寄件者: December Huang <[REDACTED]>
寄件日期: 2026年05月23日星期六 5:42
收件者: Timothy Wai Pui WU/PLAND
主旨: A/NE-TKLN/128 Response to TD's comments
附件: DD80 572S.A Swept Path Plan A7 .pdf; DD80 572S.A Layout Plan A1 .pdf; DD80 572S.A Swept Path Plan A5 .pdf; DD80 572S.A Swept Path Plan A6 .pdf; DD80 572S.A Swept Path Plan A4 .pdf

Proposed Temporary Warehouse for Storing Car Parts for a Period of 3 Years at Lots 490(Part), 491, 572S.A and 574 in D.D. 80 and adjoining Government Land, Lin Ma Hang, Ta Kwu Ling, NT

Layout Plan

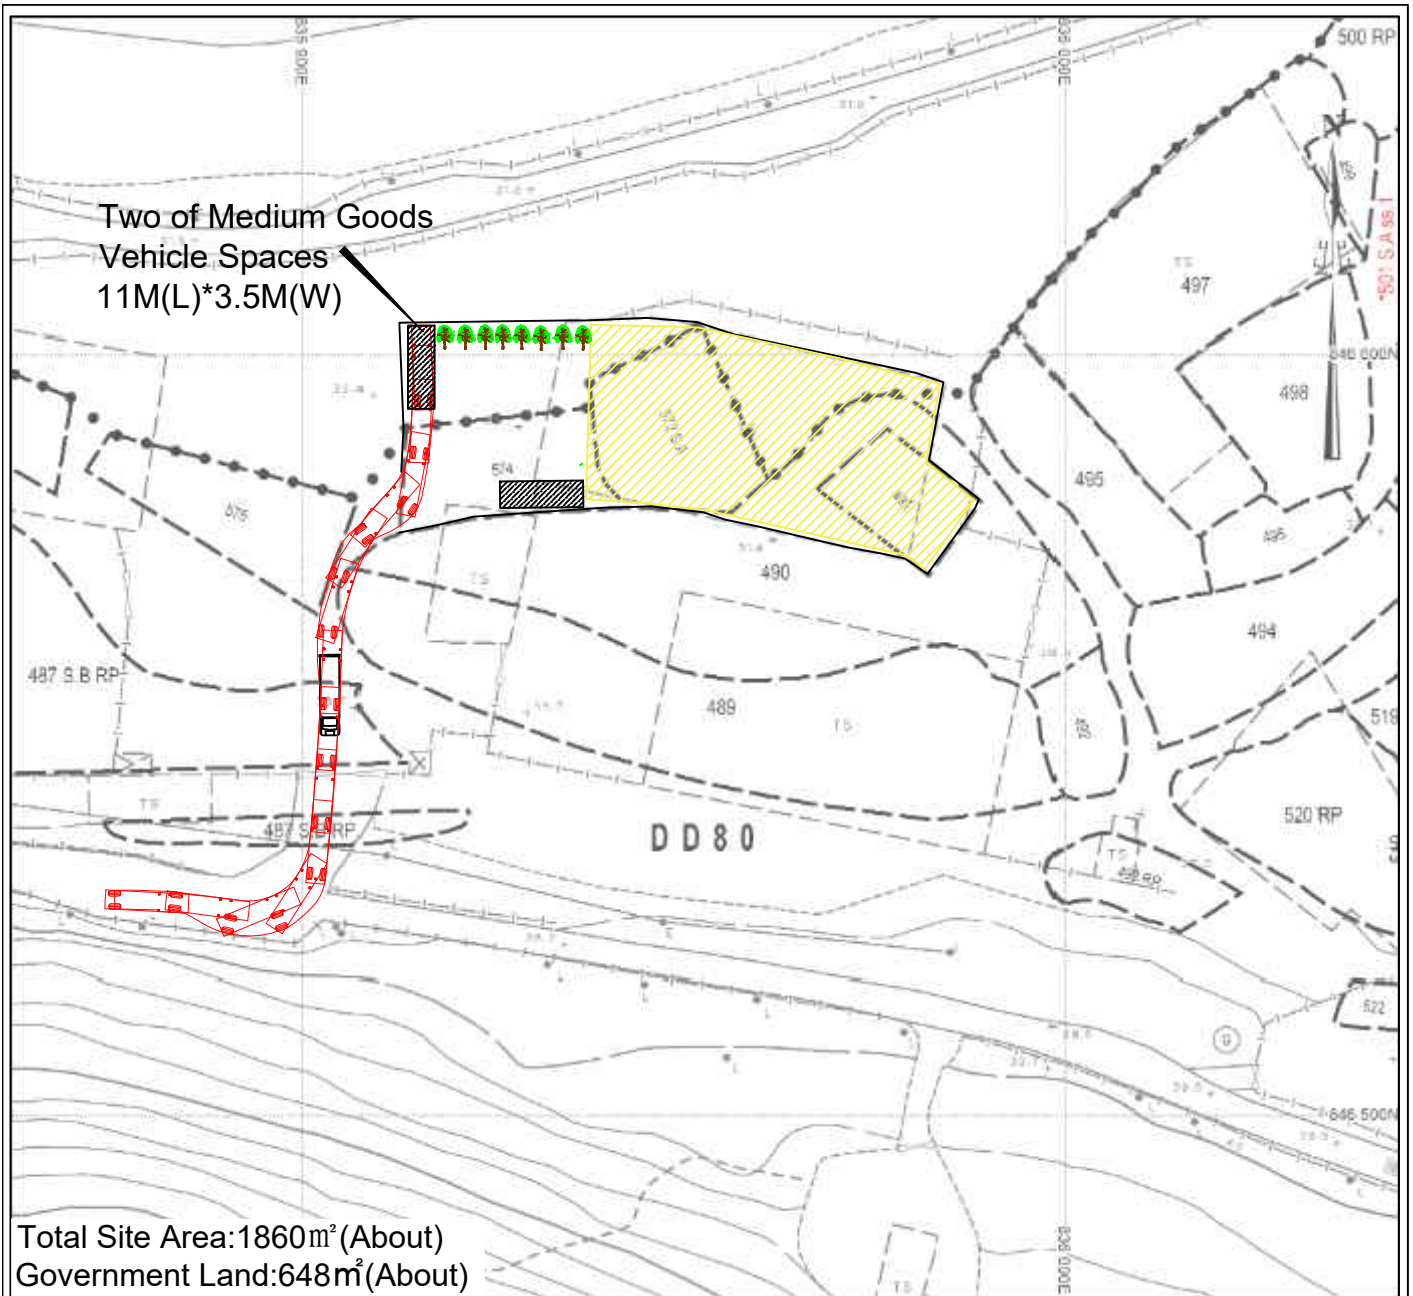
The layout plan will be reviewed and revised to show the MGV parking / loading-unloading spaces with a stall dimension of 11m x 3.5m. The location and width of the ingress/egress points will also be clearly indicated on the revised layout plan. Adequate internal manoeuvring space will be maintained within the Site so that all vehicles can enter, wait, load / unload, turn around and leave the Site in forward gear without causing obstruction to the local access road.
